**Southern Utah  
Fuel Company**

SUBJECT: SUBSTATION MODIFICATION

SUBJECT: Main Fan Diversion Modification

DRAWING NO. **85-4**

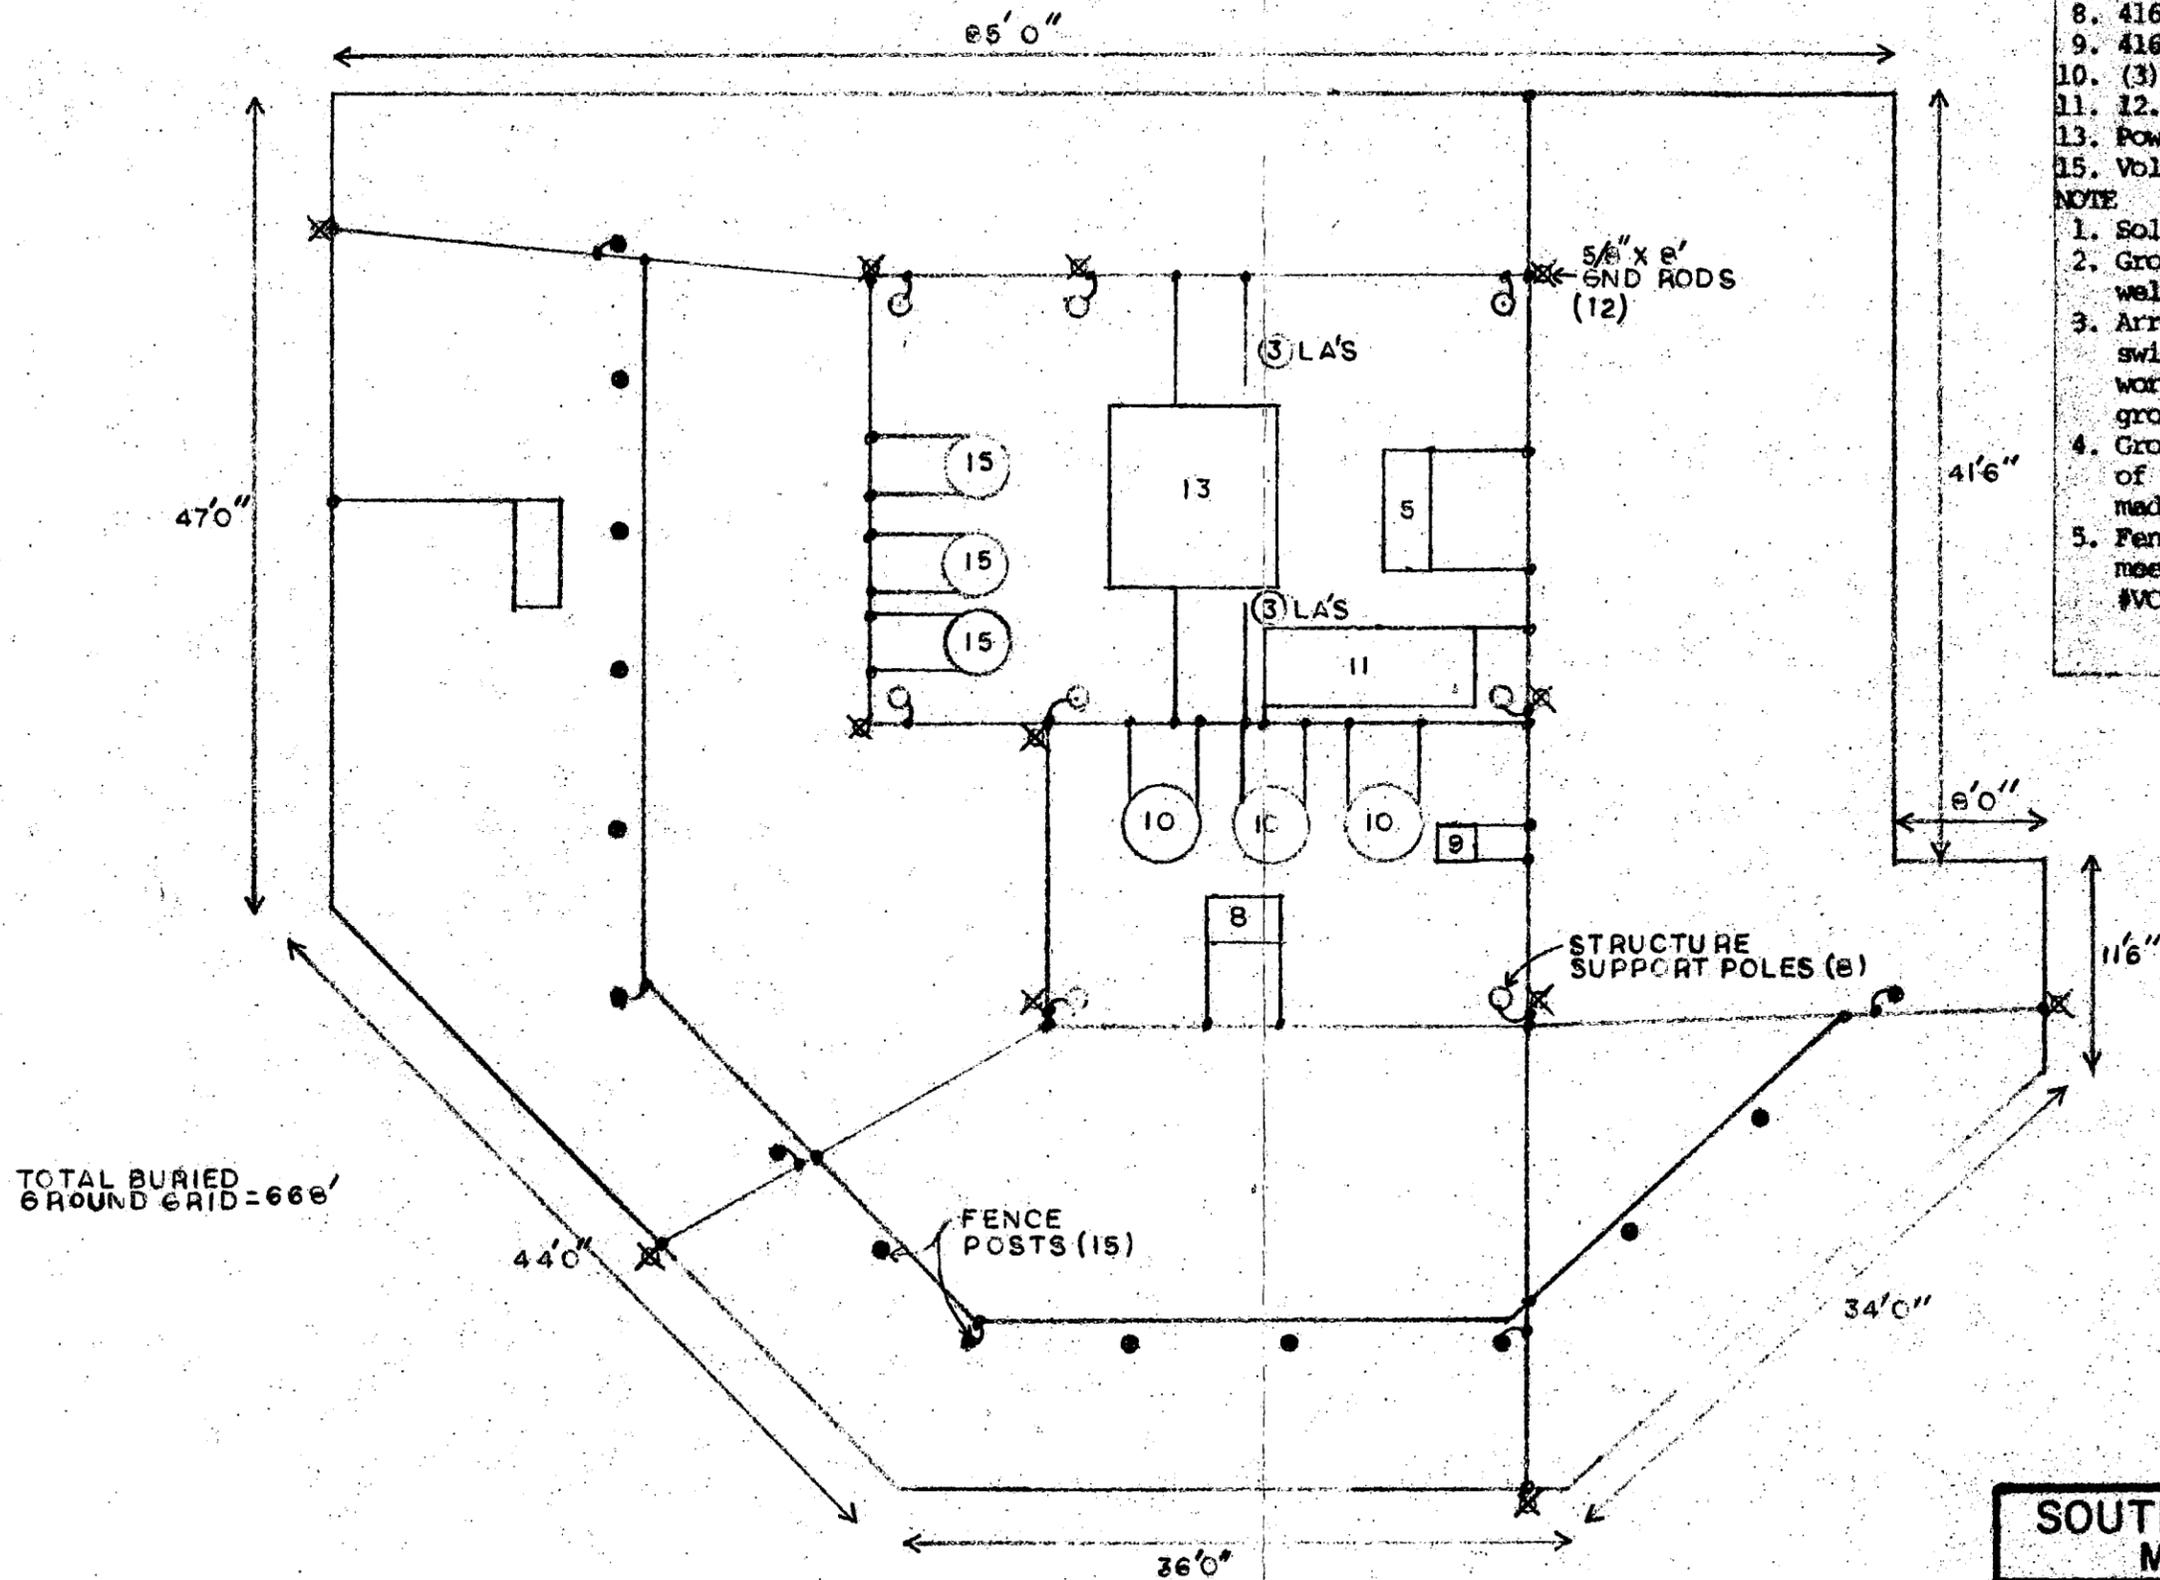
The modification project will consist of replacing the existing 25 kV/12.5 kV transformer with a 69 kV/12.5 kV transformer and expanding the existing fenced perimeter to gain required safety clearances. In addition, a grounding grid will be buried inside the fence and eight feet outside the conductive segments of the fence to conform with Utah Power and Light Company's current substation safety requirements (drawing 85 Elect 114B). The total area affected is within the disturbed area previously calculated for bonding and is shown on the enclosed topographic map number 85.4.

The topsoil from the cut extension above the present substation slope will be collected at the top of the slope. The estimated volume of topsoil is 19.4 cubic yards from a four inch depth over 1,570 square feet of surface area. After the slope has been cut back and reestablished, this topsoil will be distributed over the top of the new slope using a track backhoe. The estimated total volume of material to be excavated from the slope is 770 cubic yards. The excavated material will be used to repair the slope above the tire storage area where it has subsided and to build up the area north of the substation. The interception ditch used to bypass the undisturbed runoff from the area upslope of the substation pad will be reconstructed on the backside of the nonconductive fence from the bypass culvert drain on the north side of the substation to the undisturbed runoff interception ditch along the East Side road on the south side of the substation. Drainage area flow and ditch sizing calculations in our M&RP, Volume 8, pages 41h-5 will still apply. A revised diversion map to replace Map No. 83-2 in Volume 8 is included in this submittal.

**COAL PROCESSING FACILITIES**

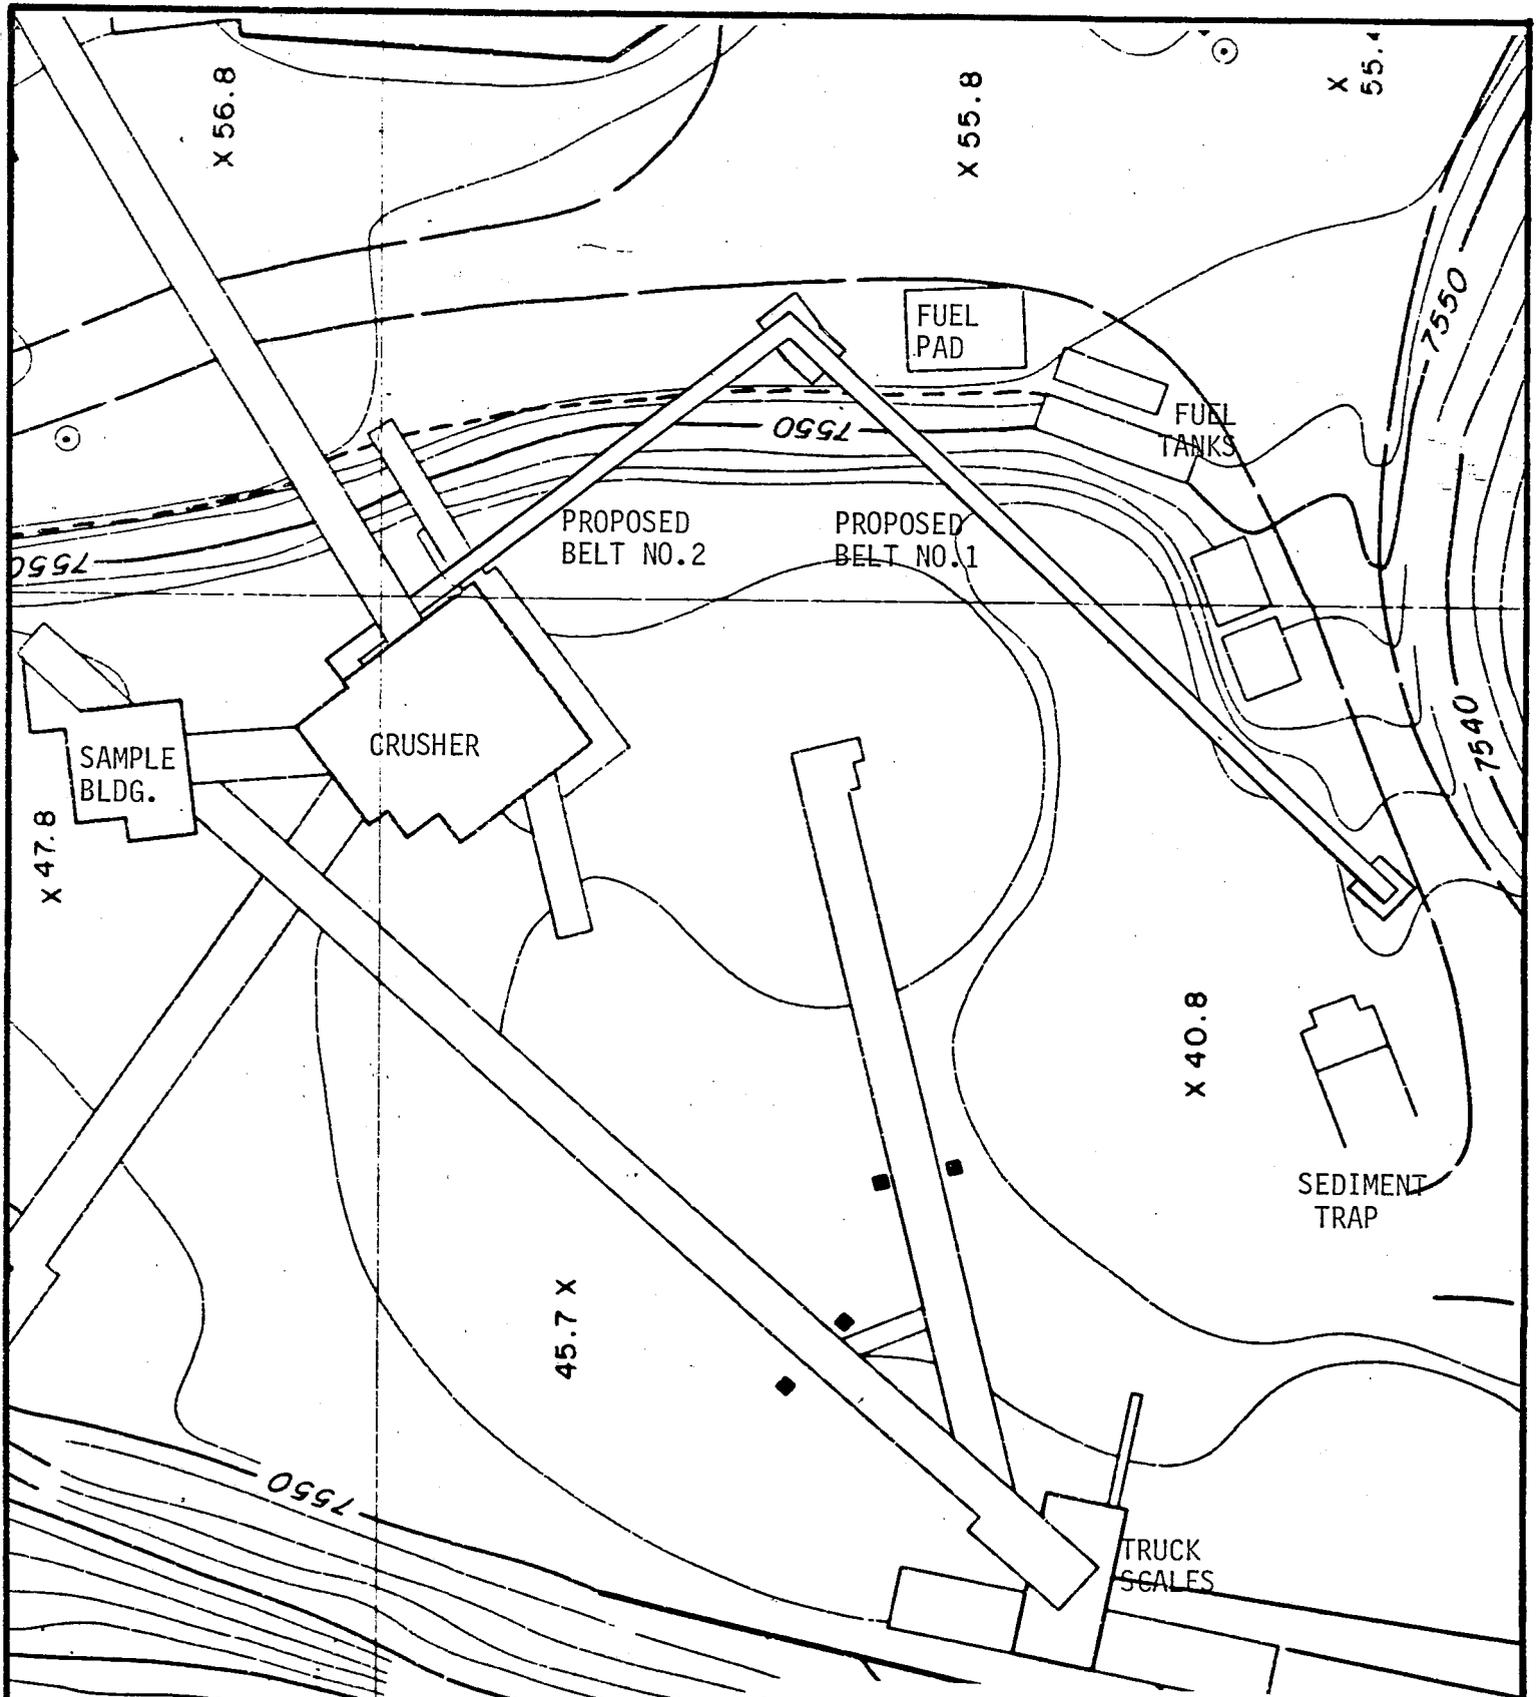
The enclosed print shows a minor change that we are currently undertaking in our coal processing facilities. Two belts are being built in the coal processing yard to allow us to reprocess run of mine coal through our specialty coal circuit. These belt lines will be suspended belts with Belt No. 1 being 160 feet long and Belt No. 2 being 125 feet long. As shown on the print, the belts will be entirely within our present yard area. The foundation at the tail of Belt No. 1 contains about 13 cubic yards of concrete. The foundation near the fuel pad contains about 22 cubic yards of concrete. This small amount of construction should not appreciably effect the reclamation schedule or bonding costs.

DRAWING NO. MAP 3

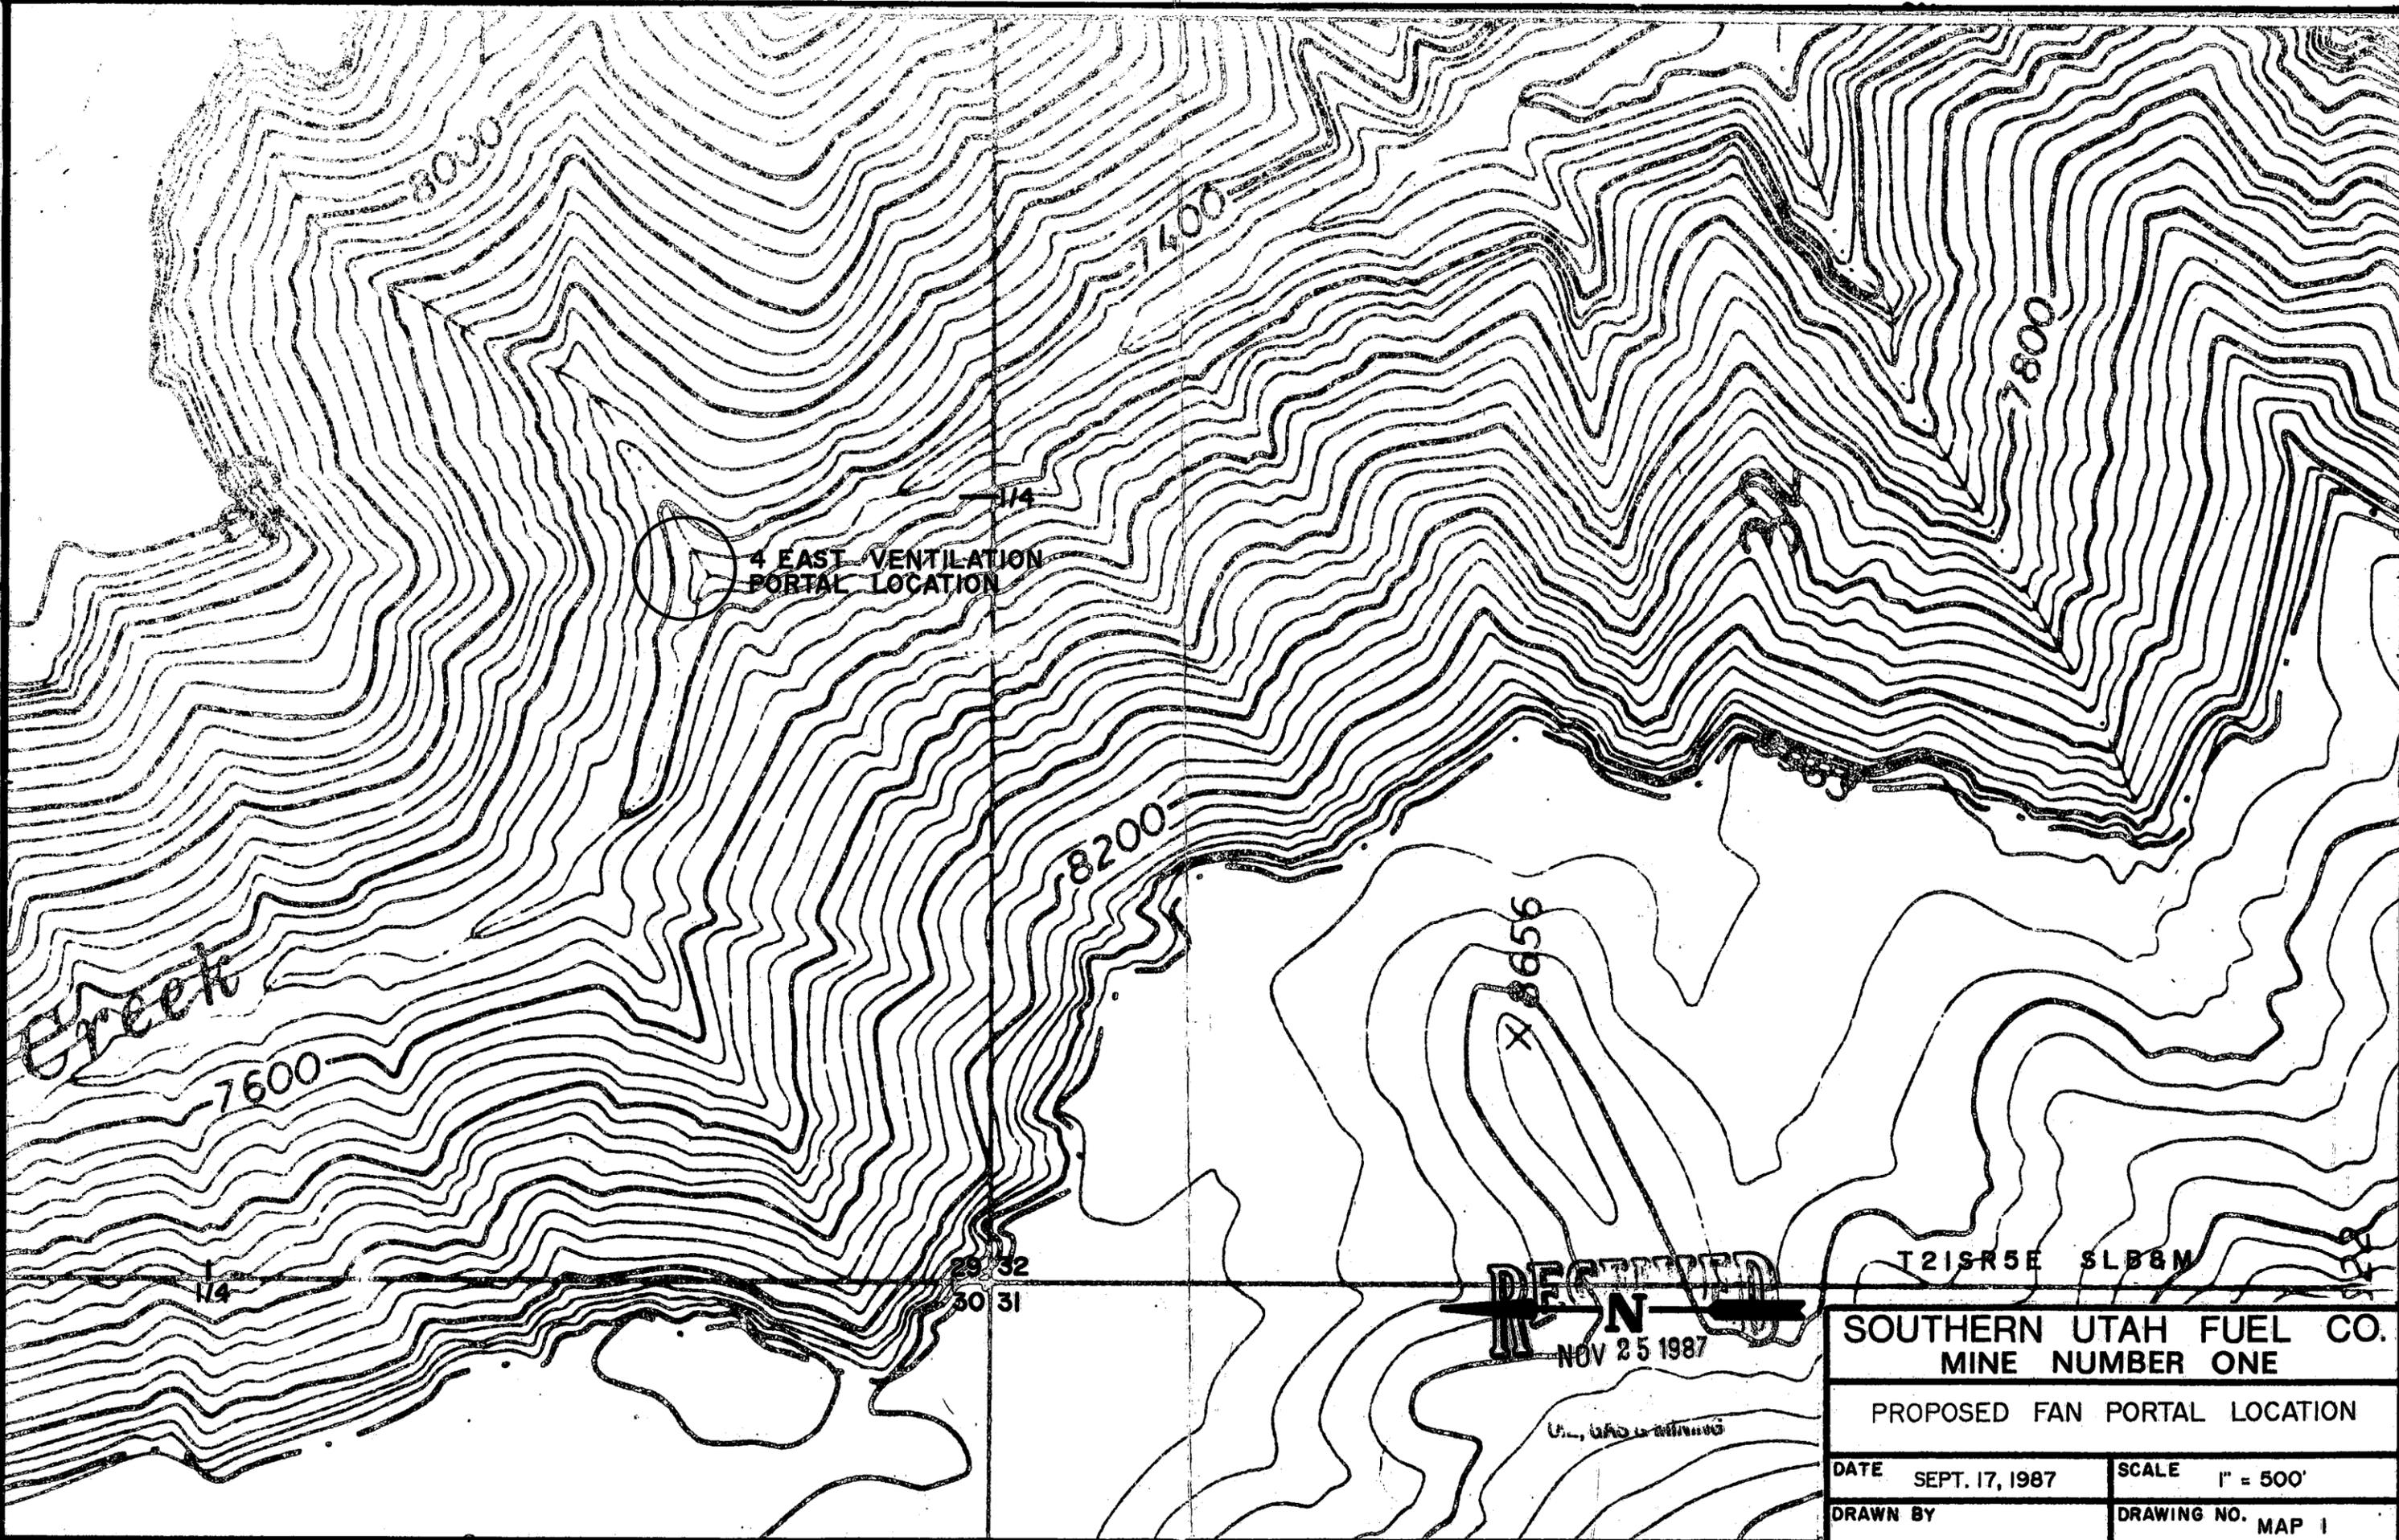
Our engineering calculations show that about 700 cubic yards of earth will need to be moved to construct the 1/4 acre fan pad shown on Map 3. This pad may be needed for a future fan location for mining the northern most reserves. Although the fan is not needed at this time, it is necessary to construct the pad at the time of the breakout. Diligent efforts will be expended to minimize the amount of disturbance at the site. Because of the thinness of the topsoil, small areal extent of disturbance, and the boulder strewn nature of the site, topsoil will not be collected.
